Subject: 10CFR21 Reporting of Defects and Non-Compliance -
Engine Systems, Inc. Report No. 10CFR21-0086, Rev. 0

Report No. 10CFR21-0086
Rev. 0: 04/18/03

**10CFR21 REPORTING OF DEFECTS
AND NON-COMPLIANCE**

COMPONENT: Woodward EGM Controls,
P/N 9903-014, 9903-016, 9903-188, 9903-460

EGM COMPONENT LAYOUT

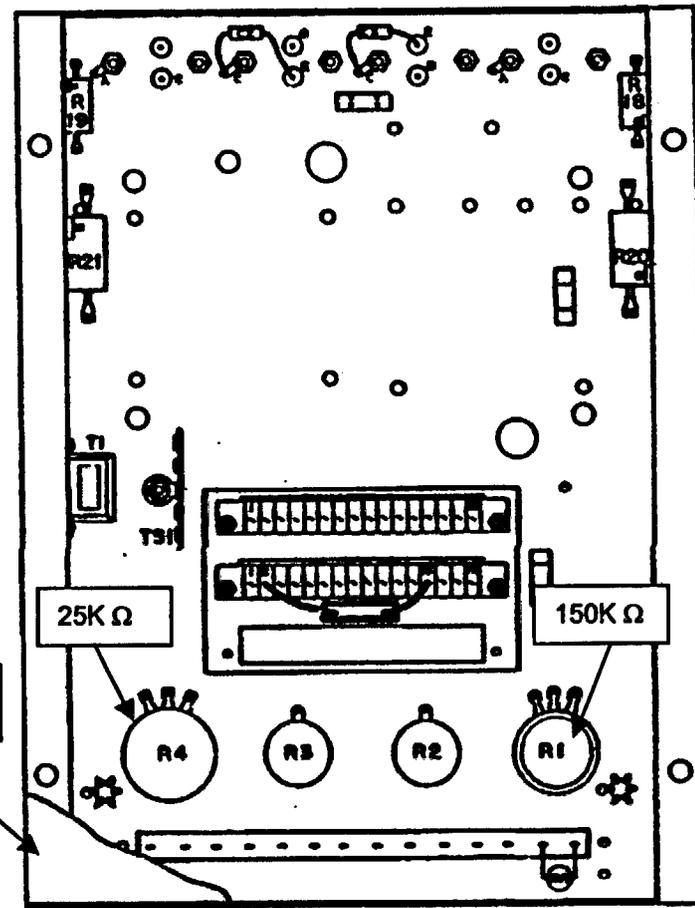
2. Users should inspect all controls listed in the Component section that have not been placed in service or with operability not verified by load testing. This inspection can be performed by removing the control's rear cover and inspecting for the following (reference Exhibit 1):

- a. The Stability potentiometer, circuit designation R1, should be 150K ohms.
 - b. The Amplifier Gain potentiometer, circuit designation R4, should be 25K ohms.

4. Controls identified as having reversed potentiometers should be sent to ESI for correction. Contact ESI's Customer Service department for information about sending a control.
